Access Compliance Report Public Rights-of-Way (Curb Ramps)

Intersection ID: 12027 Main Street: S_SUMMIT_AV Cross Street: W_MOREHEAD_ST Location: NE ADA ID: 3957A78F445D Ramp Type: Perp Initial Pass/Fail: Fail **Overall Compliance: No** Severity Score: 13.75

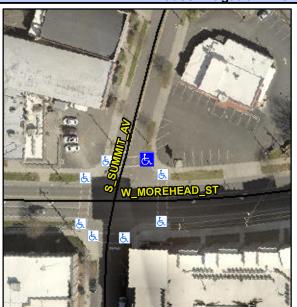
Possible Solution			Field Measurements/Component Compliance						
Possible Solutions:			Comp	liance Description	Data	Comp	Data		
Remove & Replace	Entire Ramp).	N/A	Ramp Length (in)	66.0	No	Ramp Slope (%)	8.4	
·			Yes	Ramp Width (in)	48.0	No	Ramp XSlope (%)	3.0	
			N/A	Flare Type LT	N/A	N/A	Flare Type RT	N/A	
			N/A	Flare Slope LT (%)	N/A	N/A	Flare Slope RT (%)	N/A	
			N/A	Flare Traversable LT?	N/A	N/A	Flare Traversable RT?	N/A	
			N/A	Landing Length (in)	N/A	N/A	DWS Provided?	N/A	
Surveyor Notes:			N/A	Landing Width (in)	N/A	N/A	DWS Contrast?	N/A	
N/A			N/A	Landing Slope (%)	N/A	N/A	DWS Length (in)	N/A	
			N/A	Landing X Slope (%)	N/A	N/A	DWS Full Width?	N/A	
			N/A	Landing Curb? (Y/N)	N/A	N/A	DWS Offset (in)	N/A	
			N/A	Shared Landing?	N/A				
PROW/ADA:			N/A	Gutter Ponding?	N/A	N/A	Gutter Slope (%)	N/A	
Not Found, R304.2	.2, R304.5.3		N/A	Gutter Lip Ht (in)	N/A	N/A	Gutter X Slope (%)	N/A	
,	•		N/A	Painted X Walk1?	Yes	N/A	Painted X Walk2?	N/A
